L-2020-165
GL 2004-02

RE: St. Lucie Nuclear Plant, Units 1 and 2
Docket Nos. 50-335 and 50-389
Renewed Facility Operating Licenses DPR-67 and NPF-16

Supplement to Updated Final Response to NRC Generic Letter 2004-02

Figure E1-1. Aluminum Precipitation Map for NaOH Buffer (pH < 10)

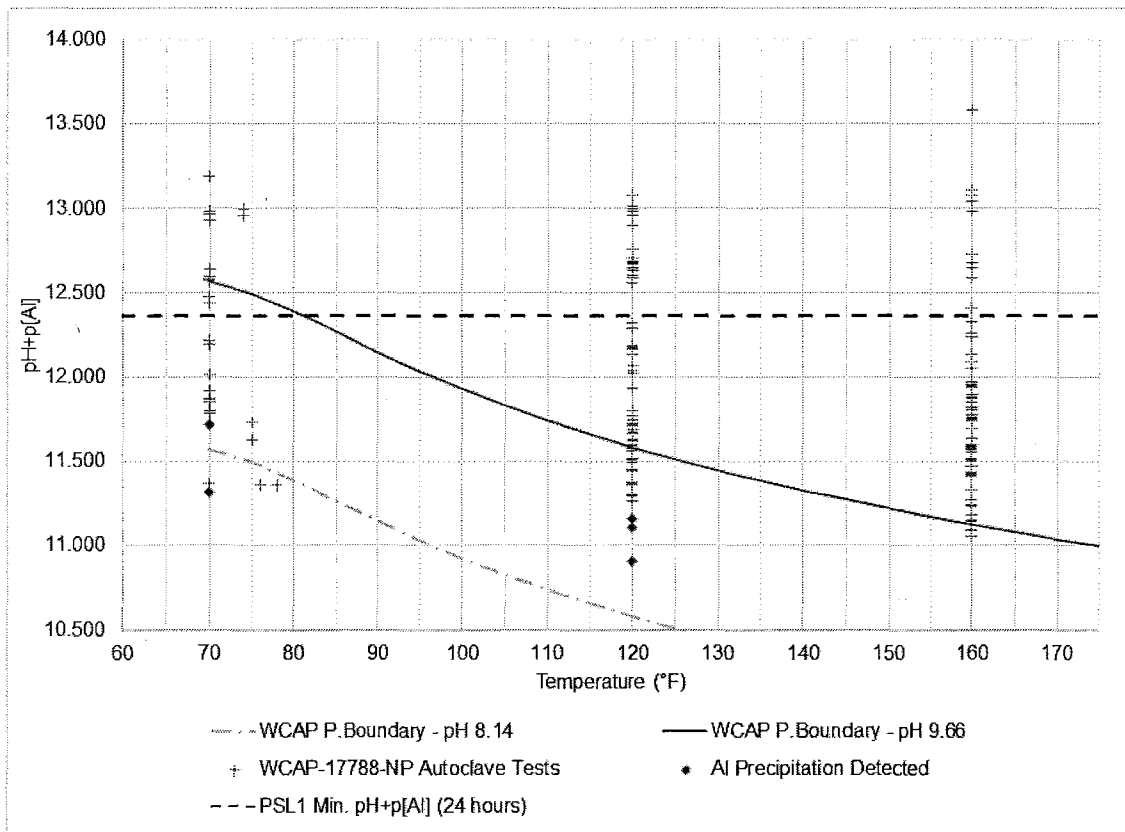
Using the maximum sump aluminum concentration at 24 hours and minimum containment sump pH of 8.14, the $pH + p[Al]$ was calculated to be 12.36 which crosses the precipitation boundary at a temperature 82°F as shown in Figure E1-1. Therefore, aluminum precipitation will not occur within 24 hours at containment sump temperature above 82°F. Containment sump temperatures below 82°F by 24 hours would be indicative of a significantly less severe accident than simulated using the WCAP-16530 methodology. Therefore, for PSL1, t_{chem} is 24 hours.

Figure E1-2: Aluminum Precipitation Map for TSP Buffer

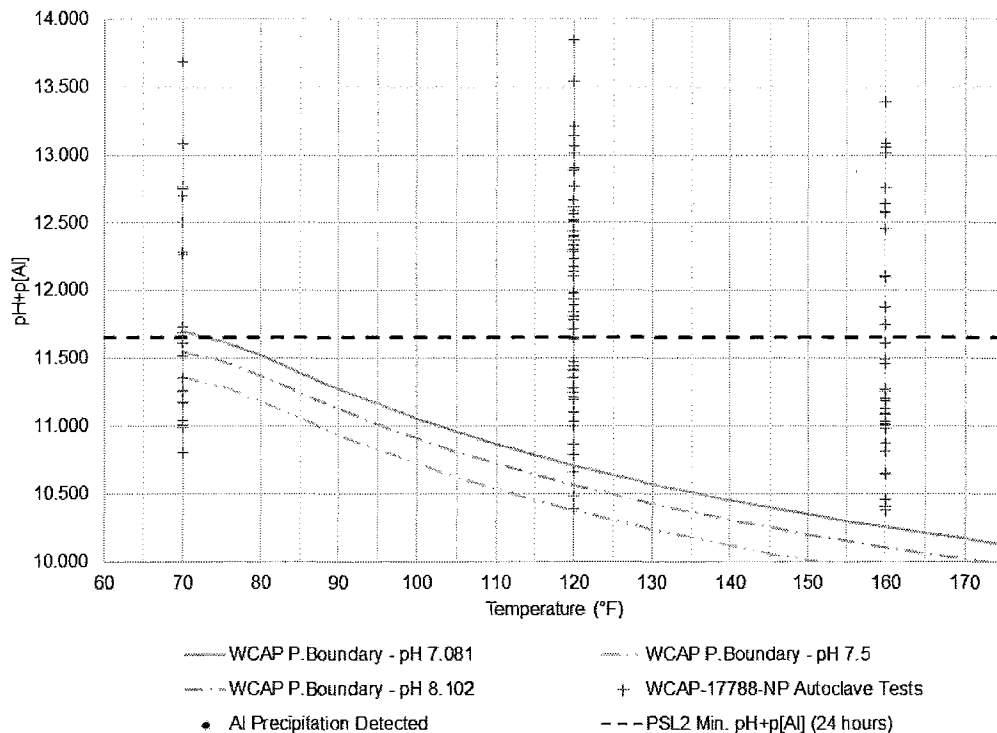
Using the maximum sump aluminum concentration at 24 hours and minimum containment sump pH of 7.081, the $pH + p[Al]$ was calculated to be 11.65 which crosses the precipitation boundary at a temperature 73°F as shown in Figure E1-2. Therefore, aluminum precipitation will not occur within 24 hours at containment sump temperature above 73°F. Containment sump temperatures below 73°F by 24 hours would be indicative of a significantly less severe accident than simulated using the WCAP-16530 methodology.
